**TOWN OF ERIE
BOARD OF TRUSTEES
August 22, 2017**

SUBJECT: Dearmin Sketch Plan - A Sketch Plan represents a generalized land use plan and layout for the area proposed to be included within a subdivision. A Sketch Plan application is required to allow for an early, informal evaluation of a proposed subdivision before detailed planning and engineering work has occurred.

PURPOSE: Review and comment on a Sketch Plan application for 765 dwelling units and 35,000 sq. ft. of commercial space.

Overall Sketch Plan

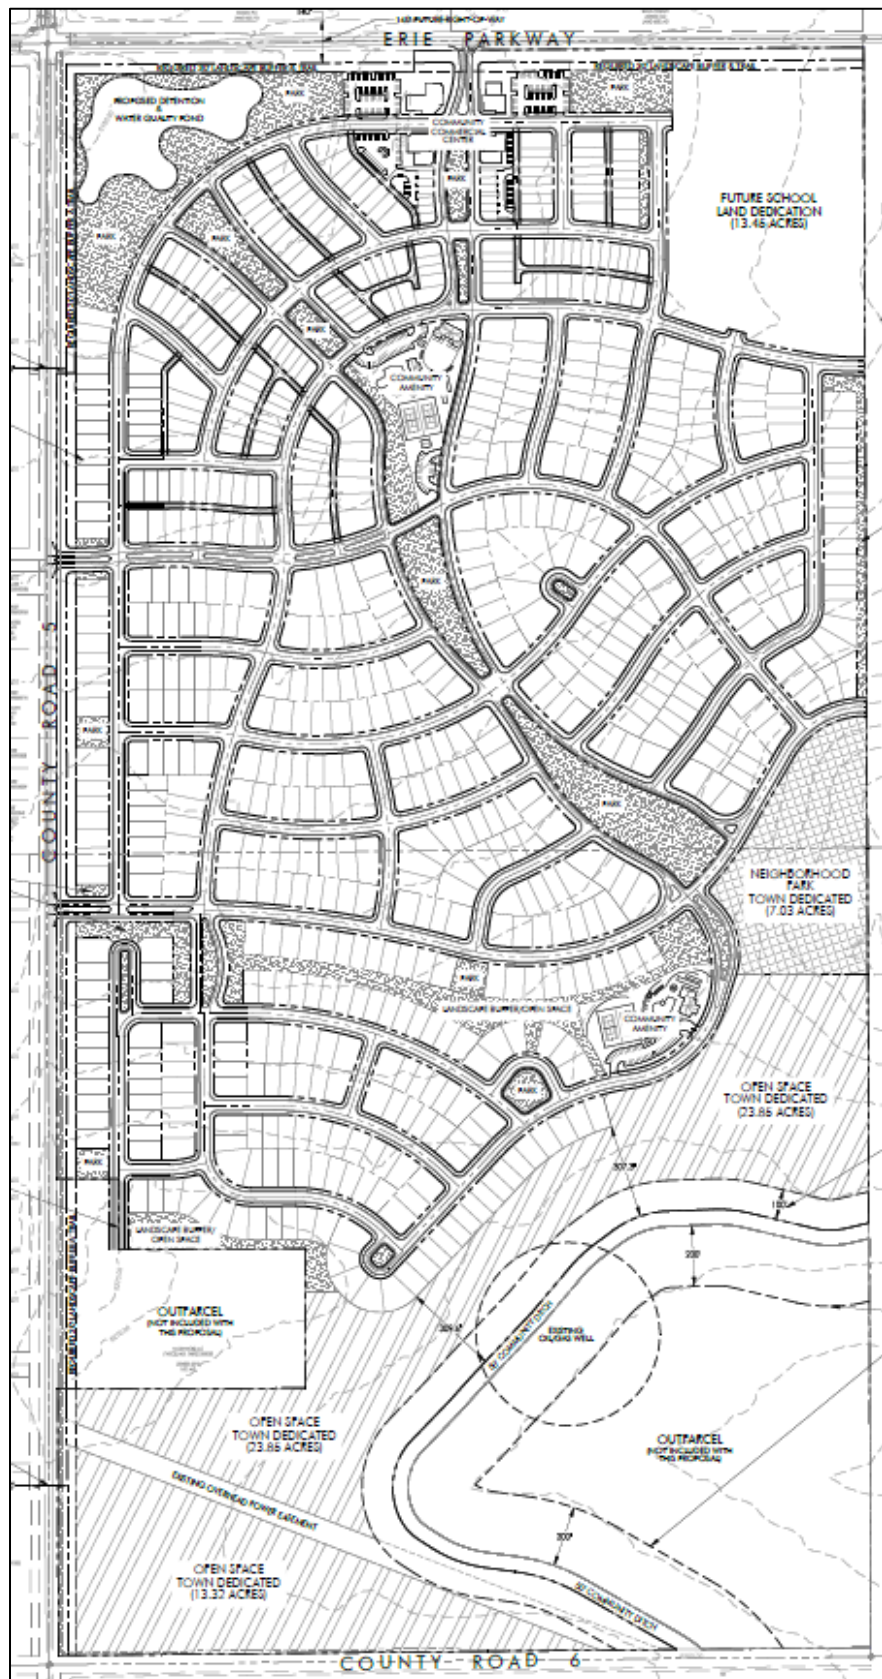
The applicants proposed Sketch Plan includes construction of the roads within the subdivision which connect to Erie Parkway to the north and County Road 5 to the west. Improvements to these adjacent existing roads will be necessary. Staff anticipates some redesign of the road network in order to address conflicts with the Town standards and additional information that will be available once a traffic study is completed.
